P802.1Qca – D0.0 Editor's Notes and Discussion Items

March 19, 2013

D0.0

Generation and distribution of an explicit path

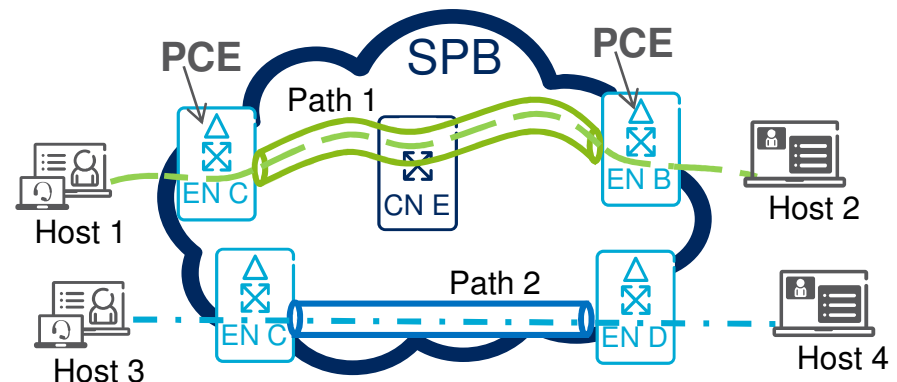
Should we have this type of figures in the spec?

IS-IS sub-TLVs for Constrained Routing

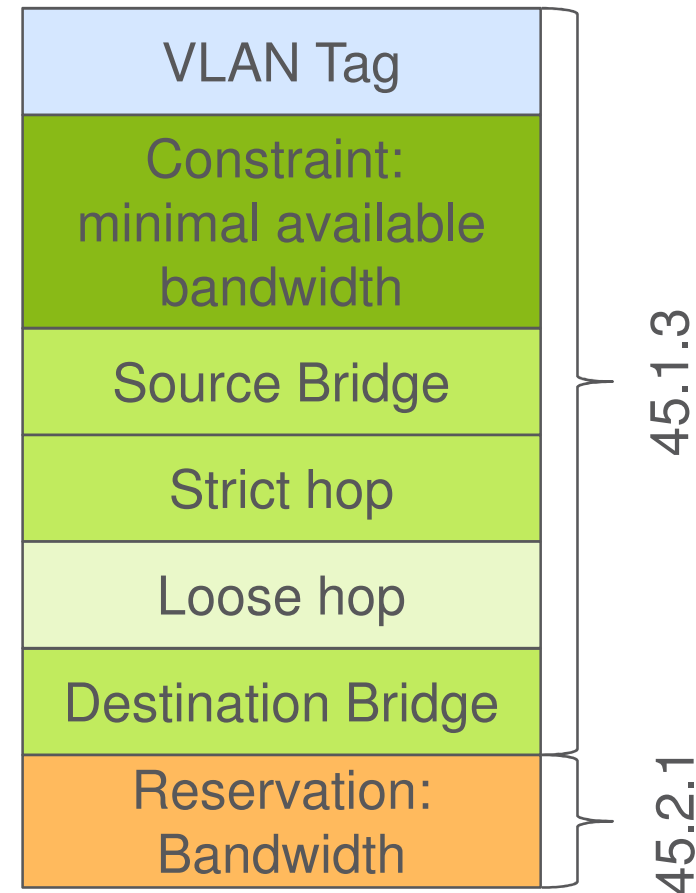
- › Described in subclause 45.1.1 Constrained paths
 - These sub-TLVs are distributed by normal IS-IS flooding (without external entity)
- › IS-IS TE [RFC 5305] defines
 - a) Administrative group (color, resource class) (sub-TLV type 3)
 - b) Maximum link bandwidth (sub-TLV type 9)
 - c) Maximum reservable link bandwidth (sub-TLV type 10)
 - d) Unreserved bandwidth (sub-TLV type 11)
 - e) Traffic engineering default metric (sub-TLV type 18)
 - **Do time-sensitive networks require further TLVs?**
- › Two sub-TLVs copied from draft-previdi-isis-te-metric-extensions-03
 - Link delay
 - Link delay variation
 - **Should we have these sub-TLVs in Qca?**
 - **If yes, then what is the relationship between Qca and the above draft?**
- › **Please, provide me input on what sub-TLVs TSN needs exactly**
